SOUTHERN NEVADA
WATER AUTHORITY

Presentation for
Jones/Mayo Cross

SNWA Application and Perennial Yield

Figure 26 Simulated Head Relative to Spring Elevation.

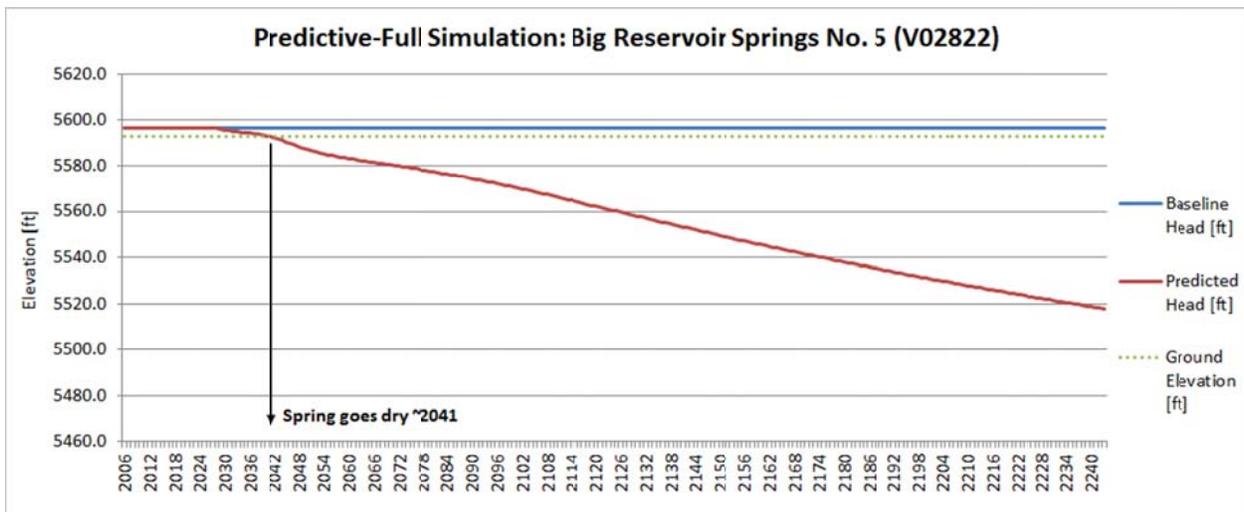
The fact that most of the springs were not explicitly represented in the model means that we cannot use the OBS process to analyze the model simulated discharge to the springs. This discharge should go to zero once the simulated head drops below the spring elevation. However, if we examine the simulated heads at the water table locations output by the OBS process (as described in the previous section), we can compare these elevations to the spring elevations in an attempt to estimate when the springs will go dry. The springs will go dry when the head drops below the ground surface elevation as shown by the intersection of the solid red line and the dotted green line in Figure 26. When conducting this type of analysis, the emphasis should be on overall trends since there is considerable uncertainty with the data associated with individual sites. This uncertainty comes from a number of factors, including but not limited to the following:

- Impact of coarse grid resolution.** The large grid cells used in the regional model can introduce significant error at individual locations even if the model is relatively accurate on a regional scale. This is especially true with springs since they are strongly impacted by local scale conditions such as fissures and localized confinement which leads to vertical head gradients. The model-simulated head represents an average value over the entire layer thickness, which is approximately 500 ft in this portion of the regional model.

- Elevation error.** The ground surface elevations may not be precise. We obtained the elevations at each of the spring locations by interpolating from a one-arc-second USGS digital elevation model downloaded from the USGS website (seamless.usgs.gov, 2011). We checked these interpolated values with a site survey at selected locations and found good agreement.

- Model calibration error.** No groundwater model is expected to precisely match field observations. A model may match overall trends in an aquifer while exhibiting a poor match between observed and simulated heads at certain locations in the model domain.

In other words, when looking at an individual spring the point in time at which the spring is predicted to go dry may be off by several years (either too early or too late), but the overall trends provides an estimate of when the springs will go dry.

Figure 26 Simulated Head Relative to Spring Elevation.

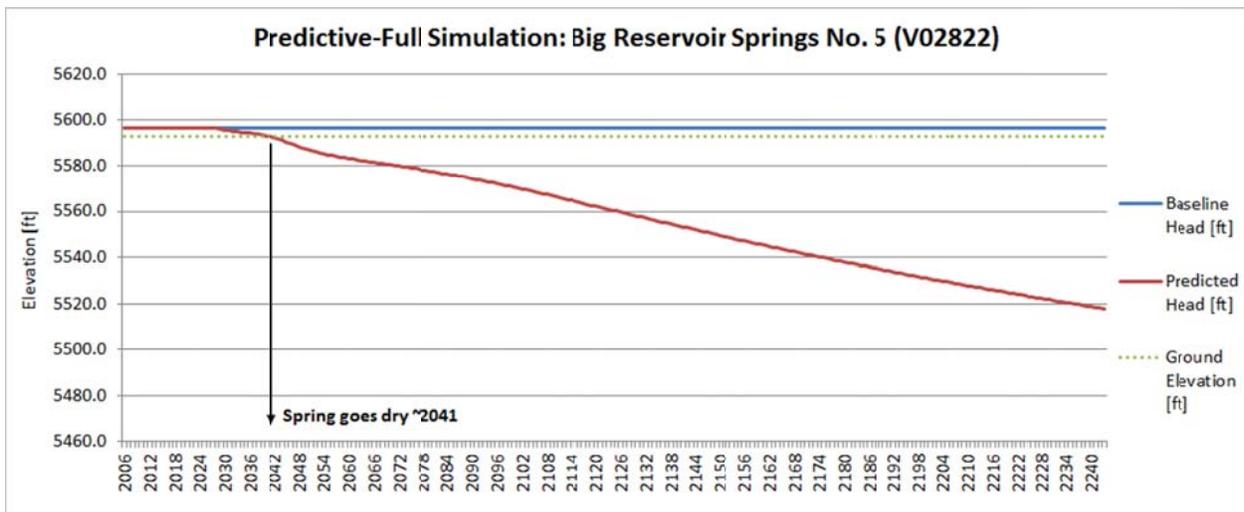
The fact that most of the springs were not explicitly represented in the model means that we cannot use the OBS process to analyze the model simulated discharge to the springs. This discharge should go to zero once the simulated head drops below the spring elevation. However, if we examine the simulated heads at the water table locations output by the OBS process (as described in the previous section), we can compare these elevations to the spring elevations in an attempt to estimate when the springs will go dry. The springs will go dry when the head drops below the ground surface elevation as shown by the intersection of the solid red line and the dotted green line in Figure 26. When conducting this type of analysis, the emphasis should be on overall trends since there is considerable uncertainty with the data associated with individual sites. This uncertainty comes from a number of factors, including but not limited to the following:

- **Impact of coarse grid resolution.** The large grid cells used in the regional model can introduce significant error at individual locations even if the model is relatively accurate on a regional scale. This is especially true with springs since they are strongly impacted by local scale conditions such as fissures and localized confinement which leads to vertical head gradients. The model-simulated head represents an average value over the entire layer thickness, which is approximately 500 ft in this portion of the regional model.

- **Elevation error.** The ground surface elevations may not be precise. We obtained the elevations at each of the spring locations by interpolating from a one-arc-second USGS digital elevation model downloaded from the USGS website (seamless.usgs.gov, 2011). We checked these interpolated values with a site survey at selected locations and found good agreement.

- **Model calibration error.** No groundwater model is expected to precisely match field observations. A model may match overall trends in an aquifer while exhibiting a poor match between observed and simulated heads at certain locations in the model domain.

In other words, when looking at an individual spring the point in time at which the spring is predicted to go dry may be off by several years (either too early or too late), but the overall trends provides an estimate of when the springs will go dry.
